February 22, 2011

**Re: Brunacini Journal Center Tracts A-2-A and A-3-A
Preliminary Grading and Drainage Plan
Engineer's Stamp dated X-X-XX (D17/D003AA7)**

BRUNACINI JOURNAL CENTER
OFFICE BUILDING
TRACTS A2 & A3

1756 Brunacini Building - Shotcrete Rundown in AMAFCA R/W

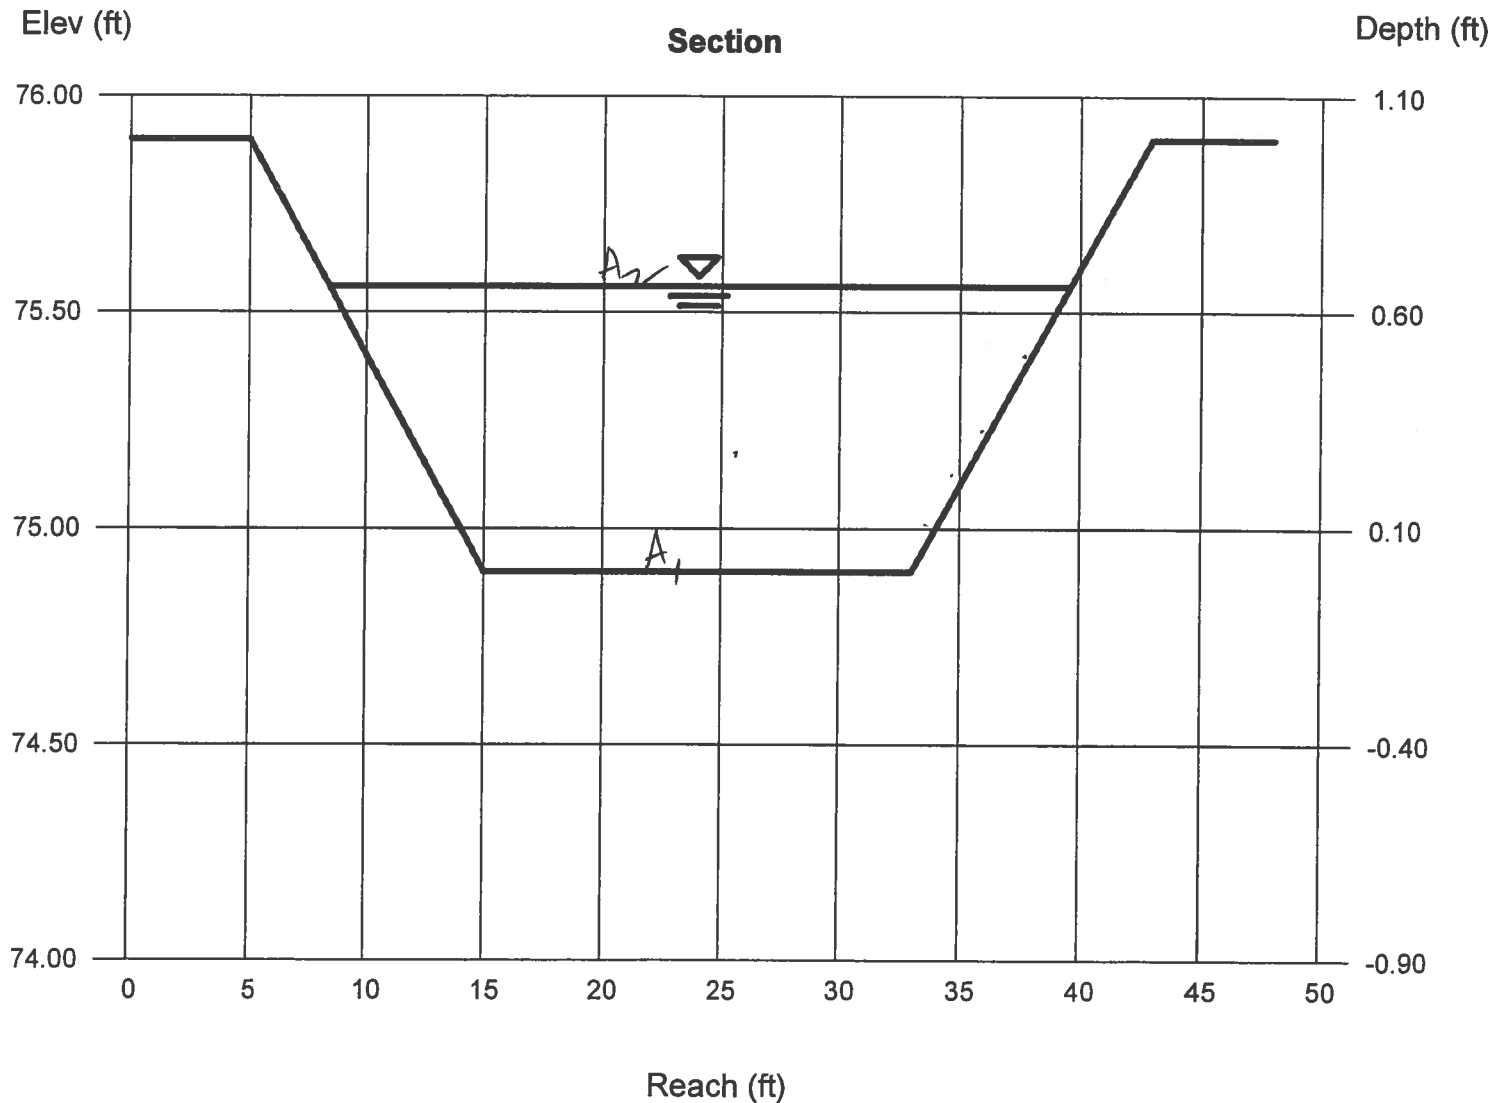
"The [Essayons Boulevard] project is a few years out and has not been approved by the AMAFCA Board of Directors or the U.S. Army Corps of Engineers. Therefore, we will require a concrete rundown connection to the existing NDC rundown structure as you have shown on the plan."

"We will also require it to extend to the south to capture the flow in the existing side inlet channel."

- Thanks for the information about the Essayons Blvd project. My plan was to make that rundown shotcrete to help keep skateboarders off of it and to reduce costs. I mis-labeled it in the notes. Does that create any difficulties?

- When you say we need to extend the rundown to the south, how far does that extension need to go? Will a dip extending 5' to 10' to the south in the side of the channel be sufficient?
